Technical Bulletin

Tension setting procedure for PSA 2.2 HDI engines

GATES REFERENCE :	5558XS/K015558XS/K025558XS/KP15558XS/ KP25558XS	
MAKE :	CITROEN, FIAT, LANCIA, PEUGEOT	
MODEL :	C5, C8, Ulysse, Phedra, 406, 607, 807	
ENGINE :	2.2 D	
ENGINE CODE :	DW12TED4, 4H01, 4HW

Fig. 2

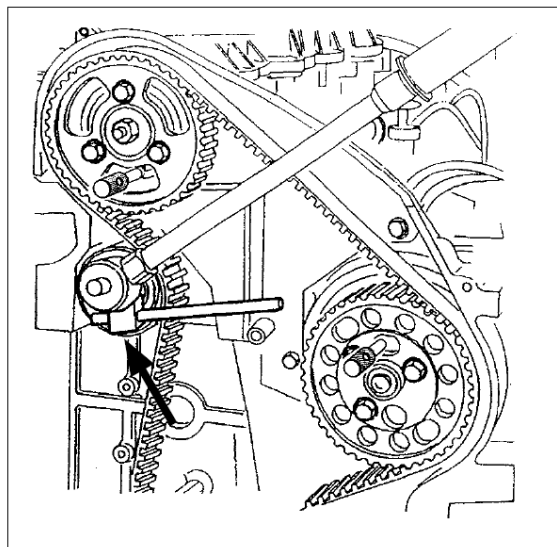
- This tool is needed in order to turn the tensioner and hold it in place while tightening the locking bolt (25 Nm) (Fig. 2).

Fig. 3

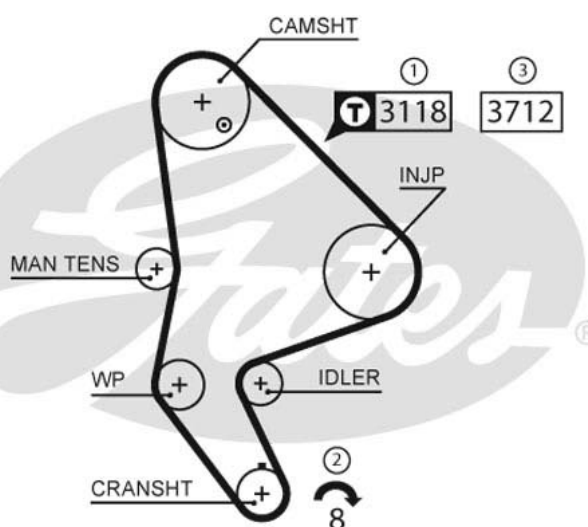
- ① - Initially, the belt has to be installed at a higher than normal tension (pretension).
The tension is measured with a Gates STT-1 tension tester in the span between the camshaft and the injection pump. Enter code 3118.
- ② - The crankshaft pulley is then rotated 8 revolutions, clockwise
- ③ - The tension is then adjusted to the final level, and the value is again confirmed with the STT-1 tension tester. Enter code 3712.

The procedure will be visualised on the PowerGrip[®] Kit and belt box label as in Fig 3.

Fig 4

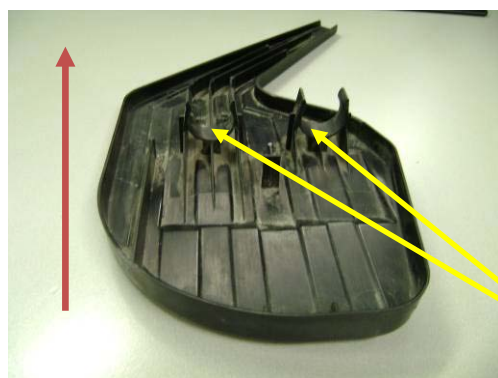
On C8 and 807, PSA recommends sliding a special water drainage cover (OE nbr 824871) under the expansion tank, so water (coming from the windscreen) can no longer infiltrate into the timing system (Fig 4). The change interval has been reduced to 120.000 KM (70.000 miles) or 5 years (3 years under adverse conditions).

Goes over hard part of expansion tank hoses.
